Technical Service Bulletin

94 Various warnings displayed in cluster, DTCs U121C00, U011000, U003600, U002800, U002900, U140500, P0A2F00, P0A1B00

94 21 37 2063075/1 April 30, 2021.

Model(s)	Year	VIN Range	Vehicle-Specific Equipment
Q5	2018 - 2020	All	PHEV
Q5	2021	000001 - 079893	PHEV

Figure 2. *Harness modification diagram.*

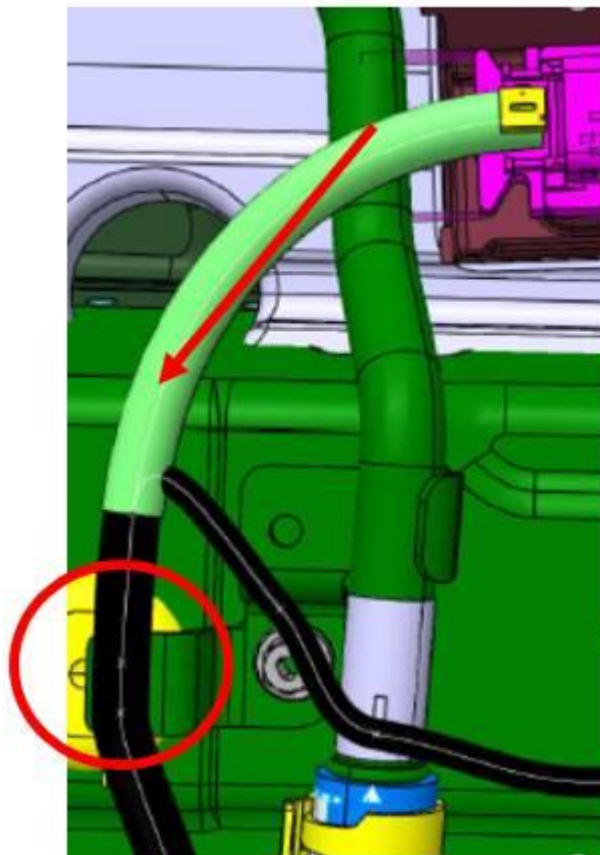
4. Expose and release retaining clip (see red circle in Figure 2).

5. Pull wiring harness 5 mm (see red arrow in Figure 2) away from power electronics.
6. Secure clip again with textile tape N 107 290 02. Clip must be replaced if it is damaged during removal (part number 6Q0 971 848 P).
7. Wrap textile tape N 107 290 02 around entire wiring harness as far as connector.

Figure 3. Secure the cable tie.

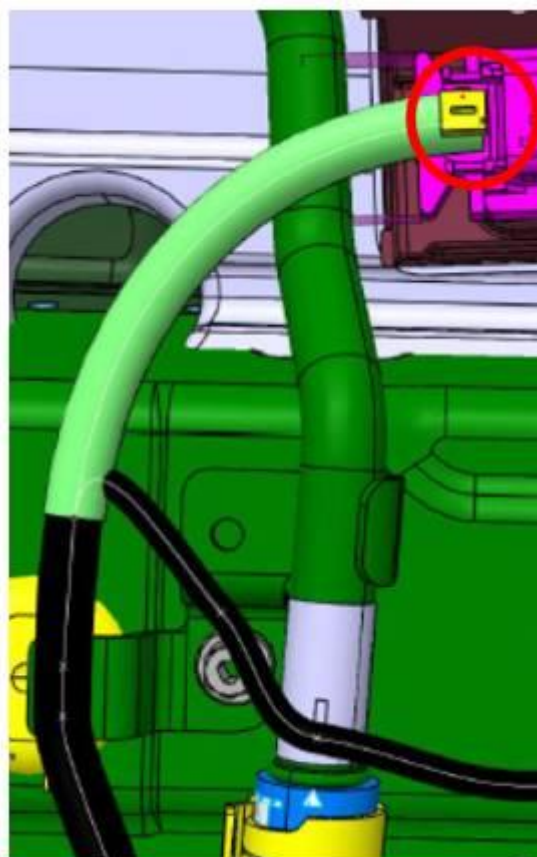
8. Secure cable tie N 106 232 01 around wiring harness and connector so that wiring harness is pulled upward (see red circle in Figure 3).

9. Ensure the wire does not make contact with any components including the undershield after the repair work is performed.
